ADDENDUM# 4

Medical Office Building - Paintsville
King's Daughters Health System
Paintsville, Kentucky

Bid Package 01 - Addendum Number Four

SHA.KDH2203

1-A4.0

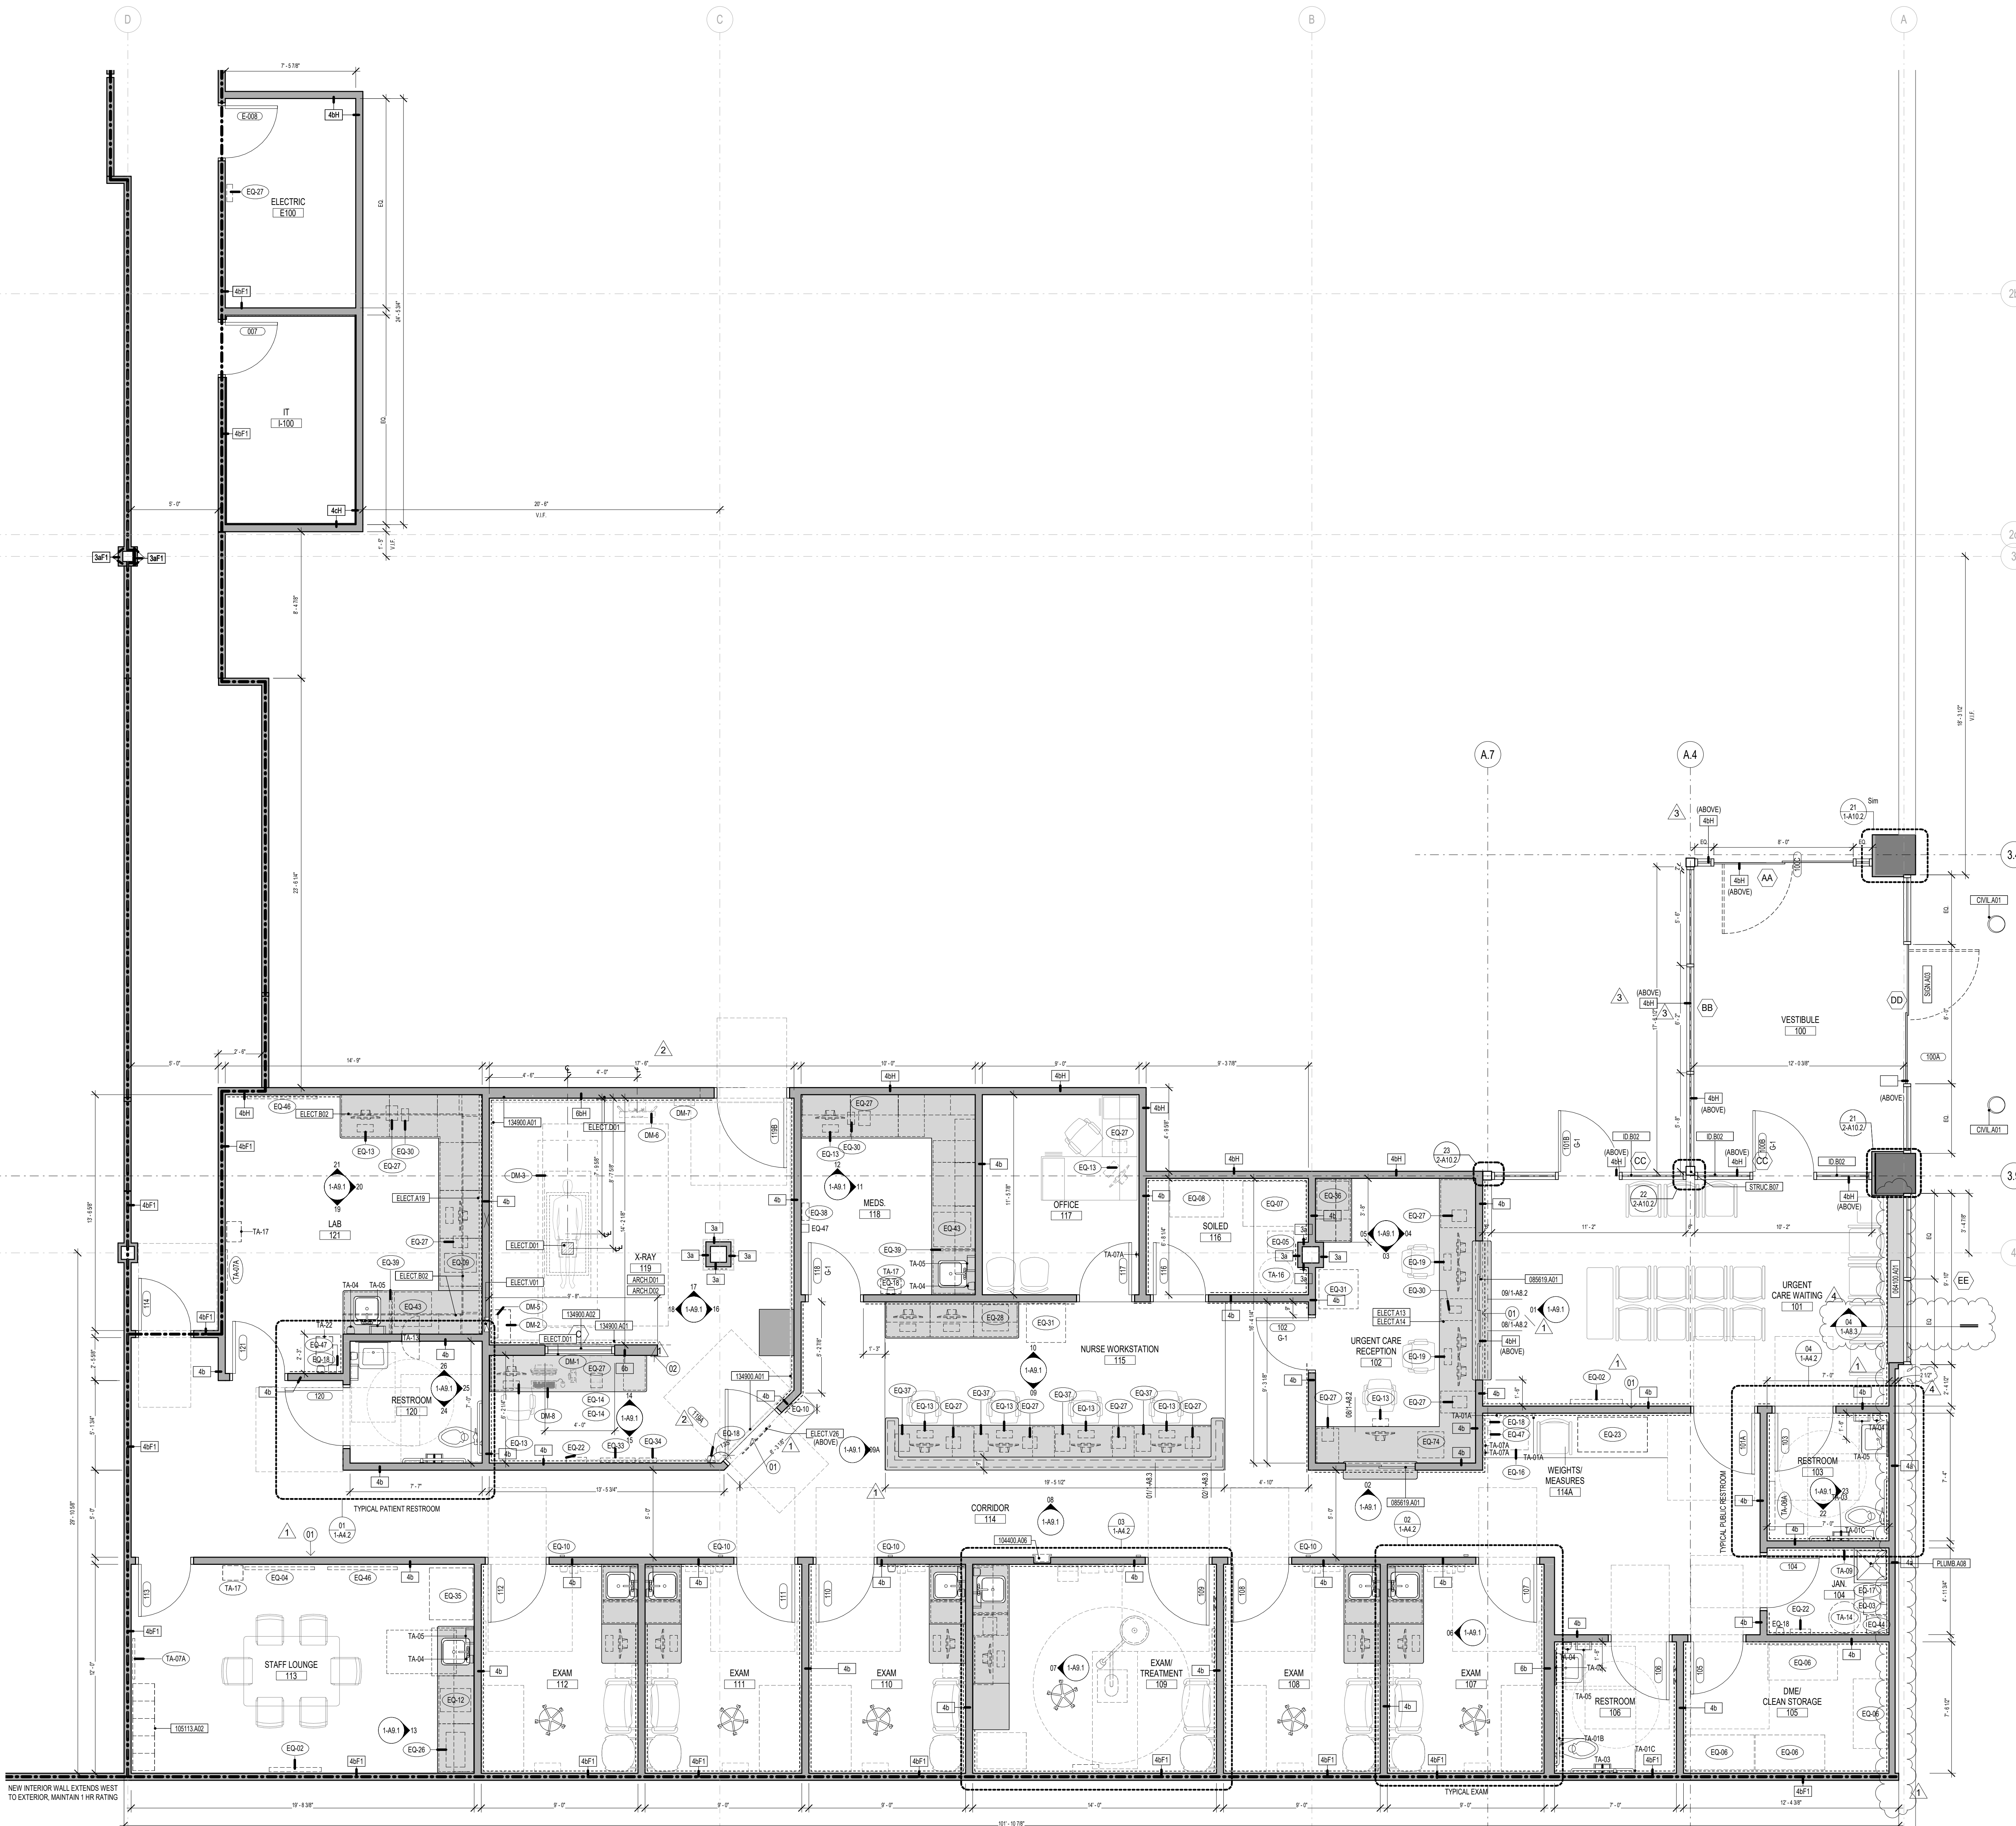
Clarification: Modified building section 04/A8.3, and shifted existing front wall to match. Added keynotes associated with changes.
